Access Compliance Report

Public Rights-of-Way

(Island Curb Cuts)

Intersection ID: 10024872	Main Street: DEWITT_LN	Cross Street: N/A	Location:	N/A
ADA ID: 2FD5414D3278	Curb Cut Type: MedianRefuge2	Initial Pass/Fail: Fail	Overall Compliance: No	Severity Score: 8.75
Codes/Mitigation Info/Possible Solution		Field Measurements/Component Compliance

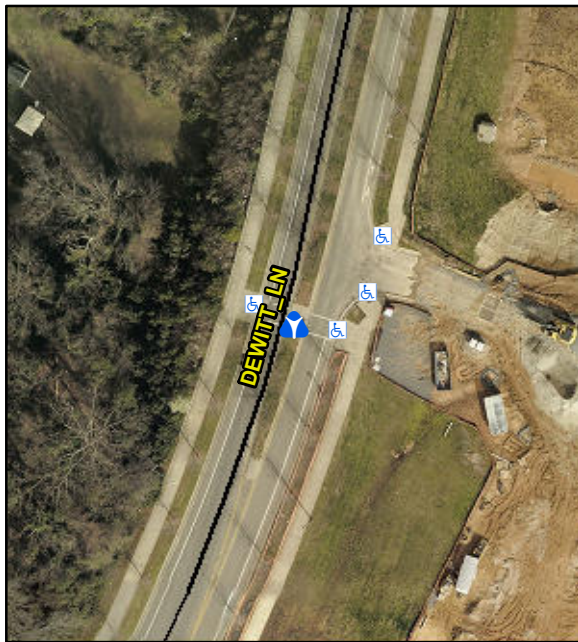
Compliance	Description	Data	Compliance	Description	Data
Yes	Refuge 1 Length (In)	48.0	N/A	Gutter 1 Ponding?	N/A
No	Refuge 1 Width (In)	48.0	N/A	Gutter 1 Lip Ht (In)	N/A
Yes	Refuge 1 Slope (%)	2.0	N/A	Gutter 1 Slope (%)	N/A
Yes	Refuge 1 X Slope (%)	2.8	N/A	Gutter 1 X Slope (%)	N/A
N/A	Painted X Walk1?	Yes	N/A	DWS 1 Provided?	N/A
N/A	X Walk 1 Direction	To E	N/A	DWS 1 Contrast?	N/A
N/A	X Walk 1 Width (In)	110.0	N/A	DWS 1 Length (In)	N/A
N/A	Road 1 Slope (%)	2.2	N/A	DWS 1 Full Width?	N/A
N/A	Road 1 X Slope (%)	1.2	N/A	DWS 1 Offset (In)	N/A
Yes	Refuge 2 Length (In)	48.0	N/A	Gutter 2 Ponding?	N/A
No	Refuge 2 Width (In)	48.0	N/A	Gutter 2 Lip Ht (In)	N/A
Yes	Refuge 2 Slope (%)	0.6	N/A	Gutter 2 Slope (%)	N/A
Yes	Refuge 2 X Slope (%)	1.4	N/A	Gutter 2 X Slope (%)	N/A
N/A	Painted X Walk2?	Yes	N/A	DWS 2 Provided?	N/A
N/A	X Walk 2 Direction	To W	N/A	DWS 2 Contrast?	N/A
N/A	X Walk 2 Width (In)	110.0	N/A	DWS 2 Length (In)	N/A

Remove & Replace Entire Refuge.
